May 12, 2018

**Re: SPLP Response to Comments
Hydrogeological Reevaluation Report
Strasburg Road/Bow Tree Drive HDD (S3-0520)
DEP Permit Nos. E15-862
East Goshen Township
Chester County, Pennsylvania**

ATTACHMENT 1
WATER SUPPLY ILLUSTRATION

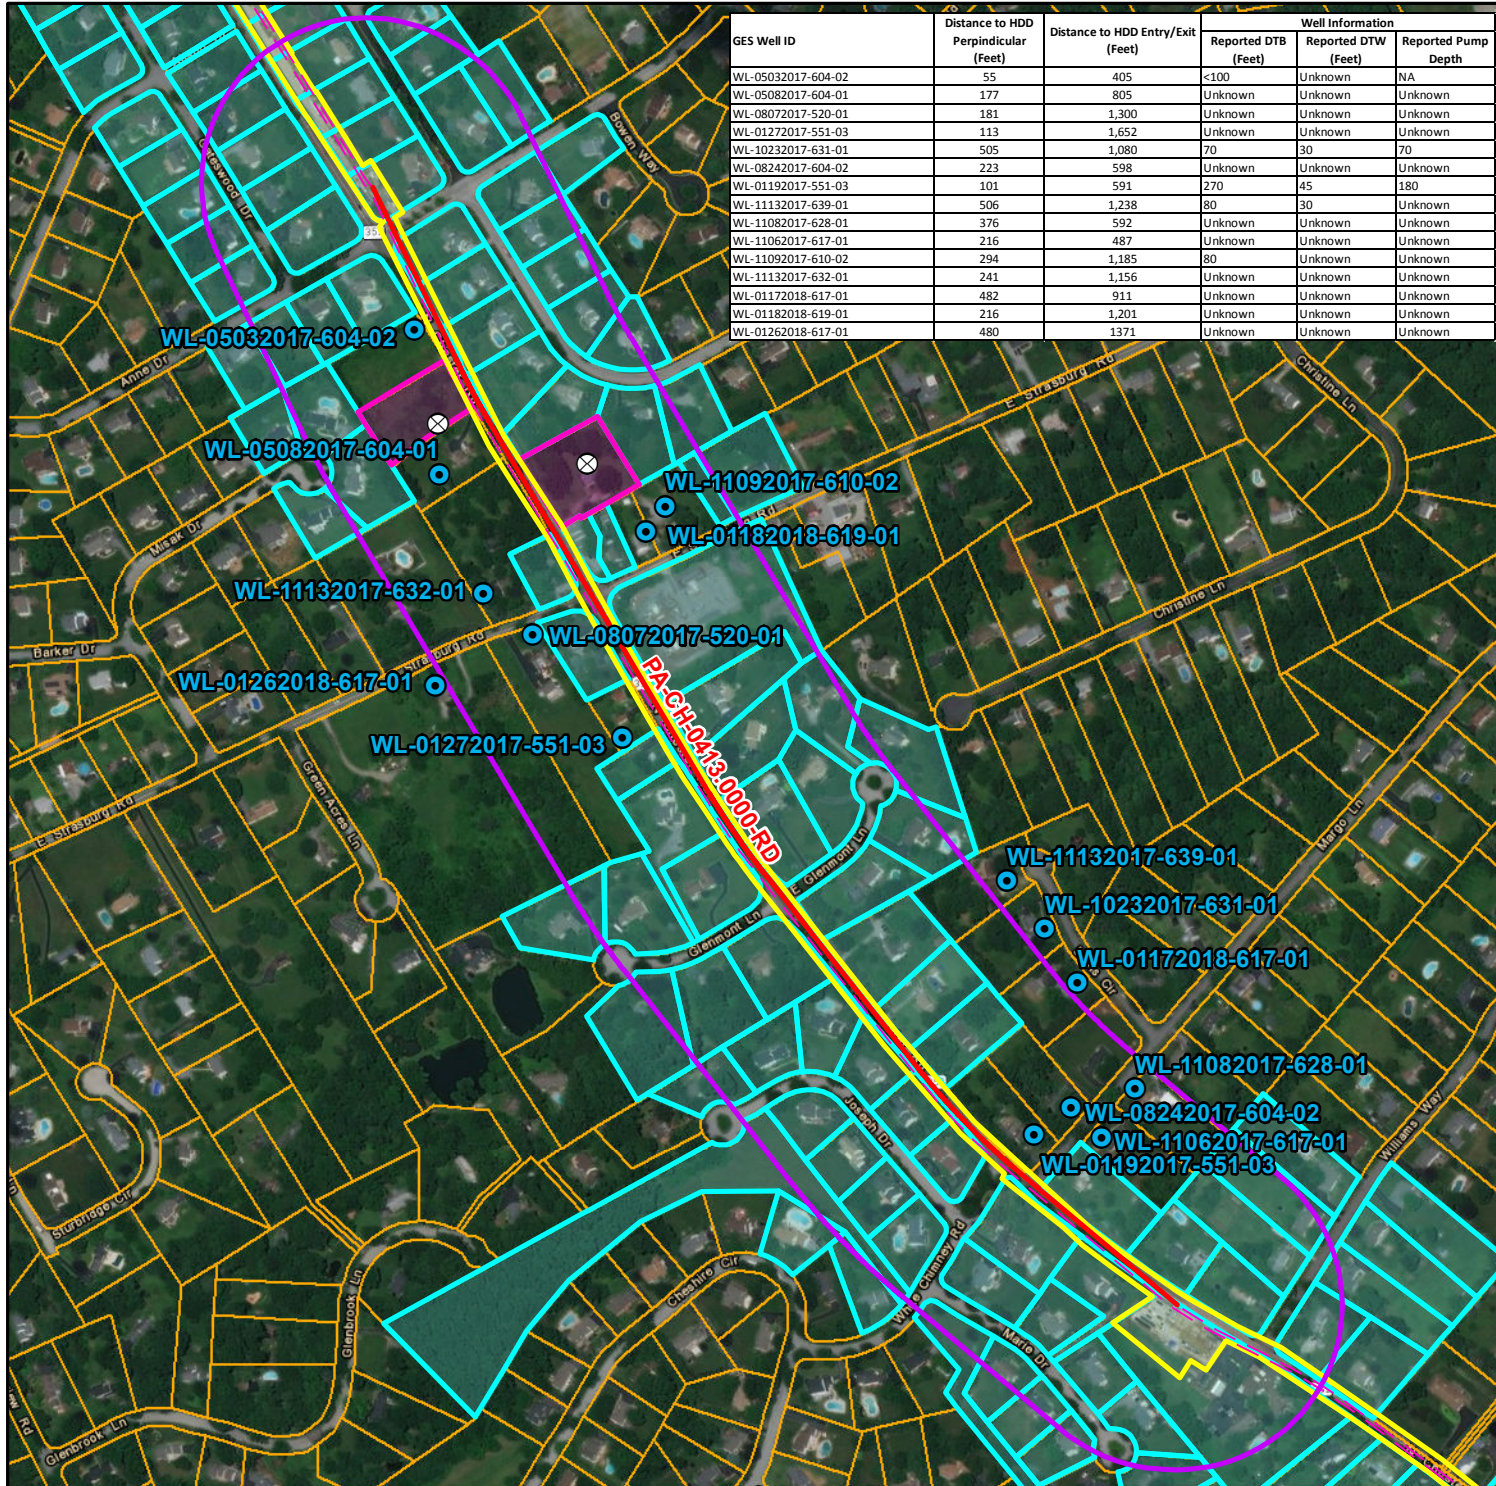
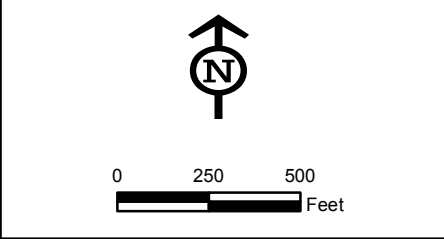
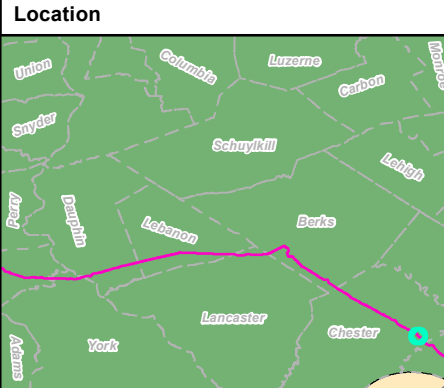
8. The implementation of an early detection groundwater monitoring program using domestic wells was not incorporated. A map of wells along with a time frame of drilling activities should be presented in such a monitoring plan.

- c. At least 10 properties have private water supply wells within 450 feet of the proposed HDD. Two additional properties have private water-supply wells located just beyond the identified 450-ft boundary. An additional 13 properties are located within 450 feet of the proposed HDD and may or may not have private water supply wells. The Report should include a specific plan for temporary supply replacements, as the bedrock is highly fractured, even at depth, and residential water supply wells are located as close as 55 feet from the planned bore path. To limit potential impact on residential water well users, there should be a well-conceived response plan in place and ready to execute.**

A new Water Supply Illustration is provided with this response as Attachment 1. As shown on this illustration there are eleven (11) landowner identified private water wells within 450 ft of the HDD profile. Of these, two (2) are vacant properties. The remainder of the properties are served by public water supply.

As presented in SPLP's response to Item 8, there are eleven (11) landowner identified private water wells within 450 ft of the HDD profile and two (2) of these are vacant properties. The remainder of the properties are served by public water supply. Four properties with private water wells occur adjacent to, but outside, the 450 ft buffer.

The water supply illustration provided as Attachment 1 to this response is an accurate presentation of the known water supply wells. The well locations were recorded by GPS.

ATTACHMENT 2
HDD PLAN AND PROFILES, WITH FRACTURE TRACE LINES, AND WELL/WATER
DATA

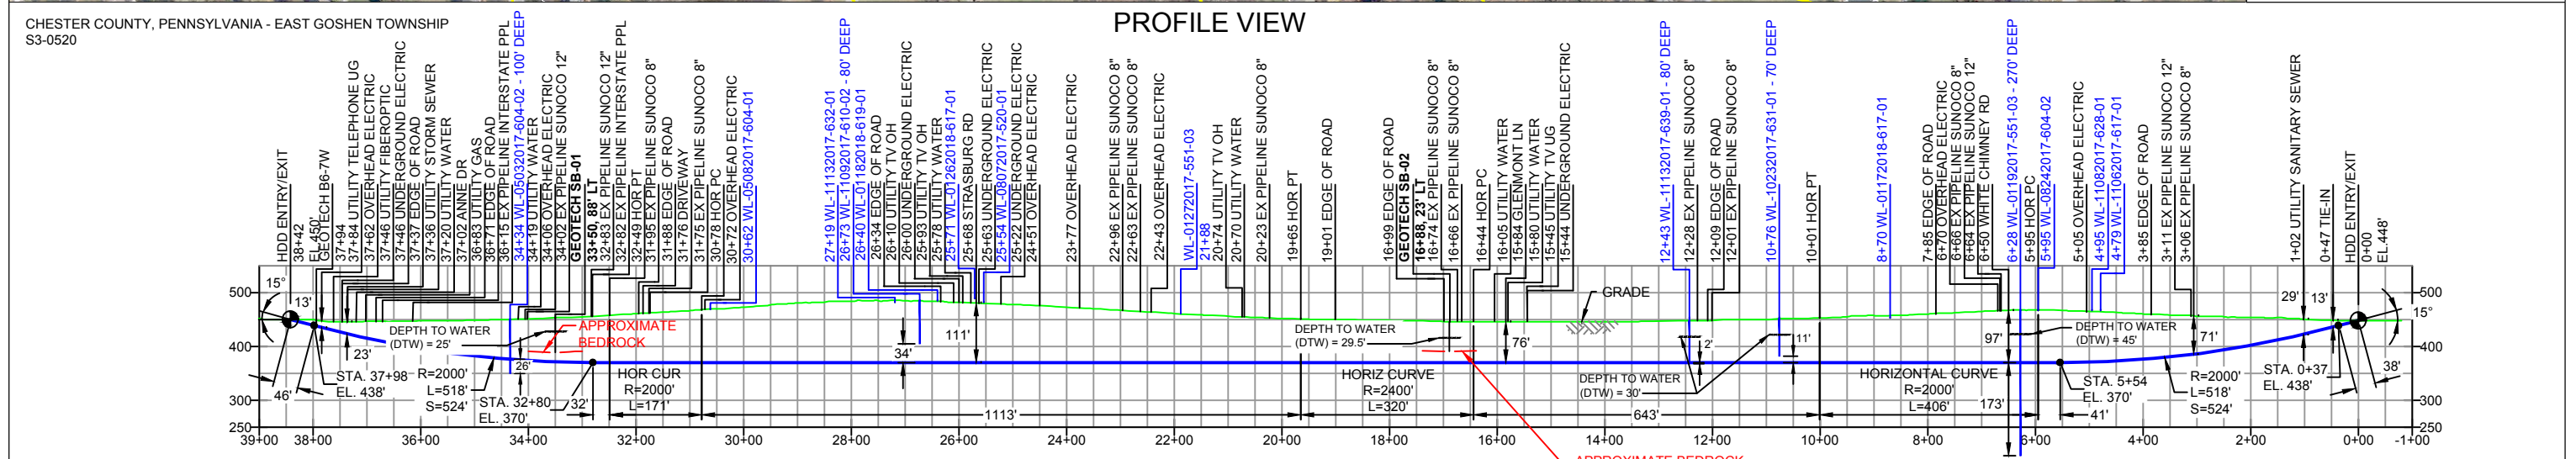
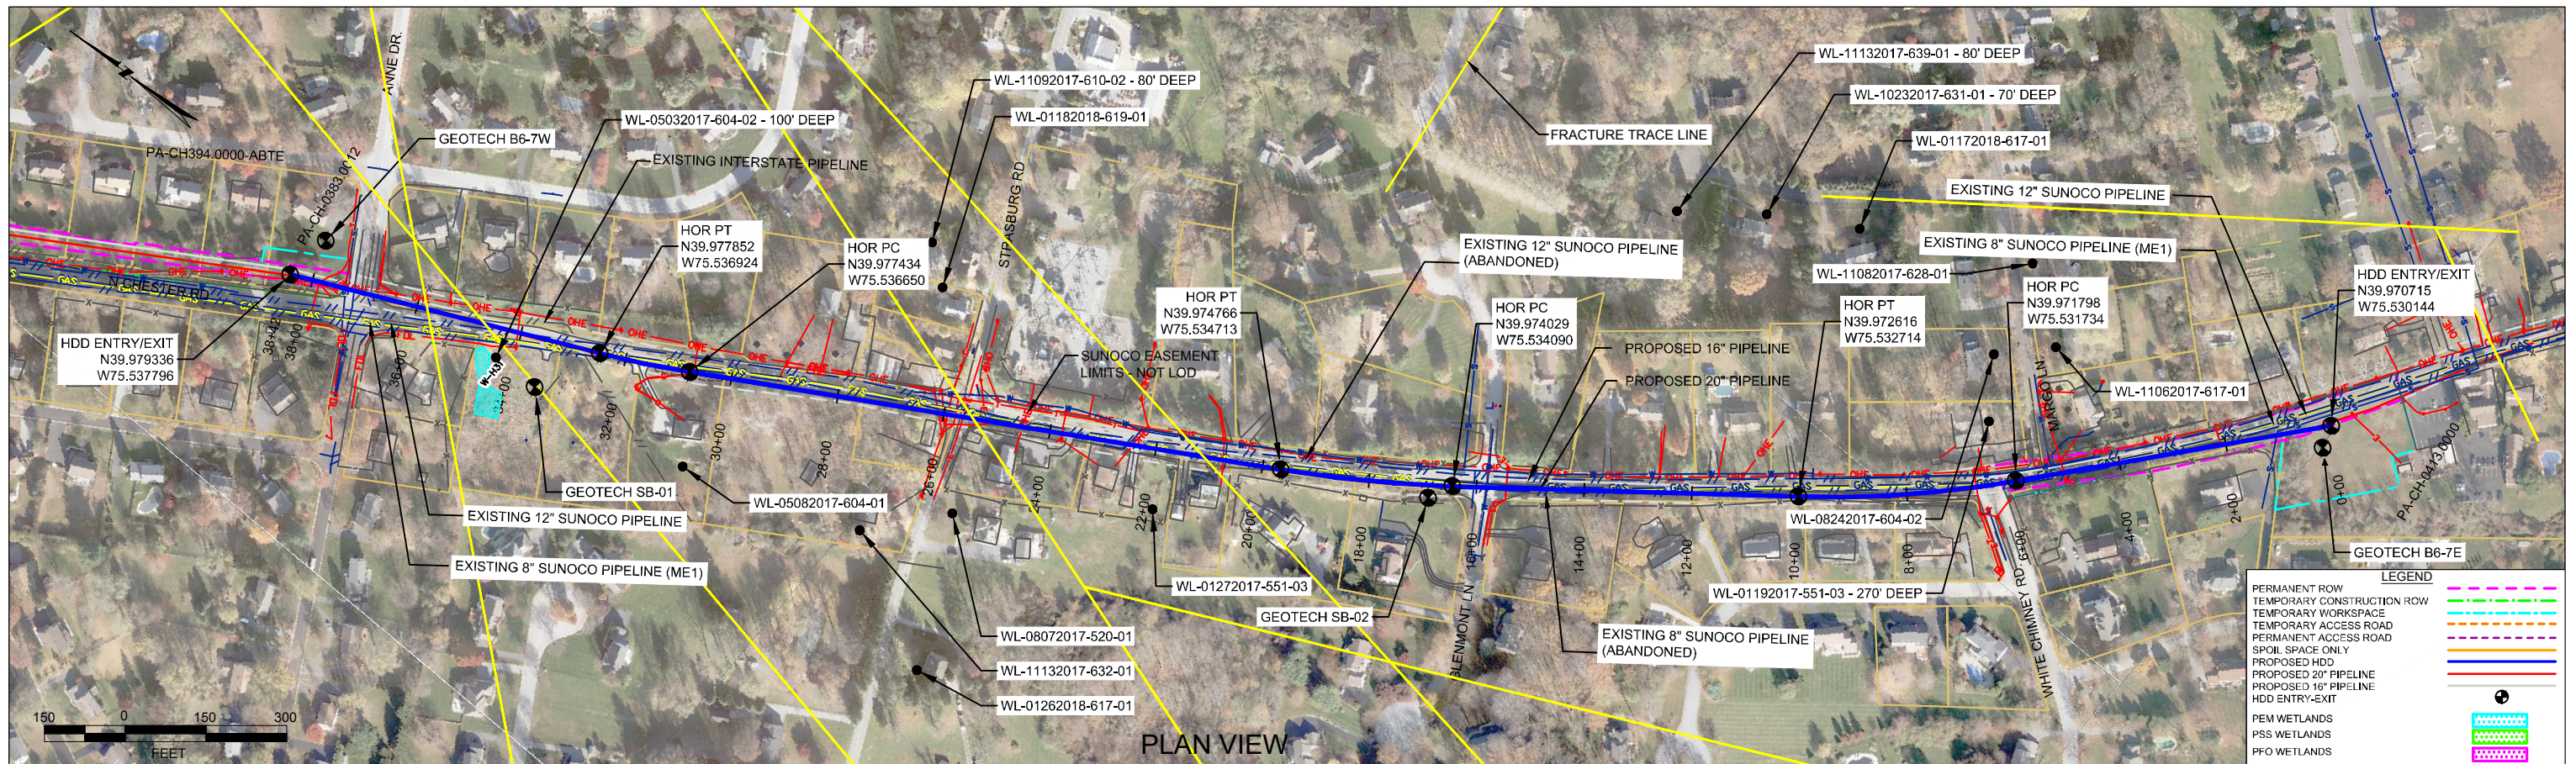
15. Evaluation of water levels should be performed prior to initiating the HDD bore to provide information regarding potential diminution of flow issues and the ability to determine if any future potential impact is related to head differentials or plugging of a potential water-bearing zone.

- a. Evaluate and project water well depths, casing depths, and water-level depths (based on a water-level survey) on cross sections/profile views.

- b. The GES Report identifies the fractures on a plan view. The Report should also identify potential zones of fractures or fracture trace intercepts on the profile views, along with residential water supply well locations.**

The HDD plan and profiles provided in Attachment 2 have been modified to include known groundwater levels obtained during geotechnical investigation and from adjacent water well data.

As referenced in Item 16a, the HDD plan and profiles provided in Attachment 2 present the water well locations, well depths, and static water levels.

As referenced in Item 16a, the HDD plan and profiles provided in Attachment 2 present the fracture trace intercepts along with water well locations and depths.
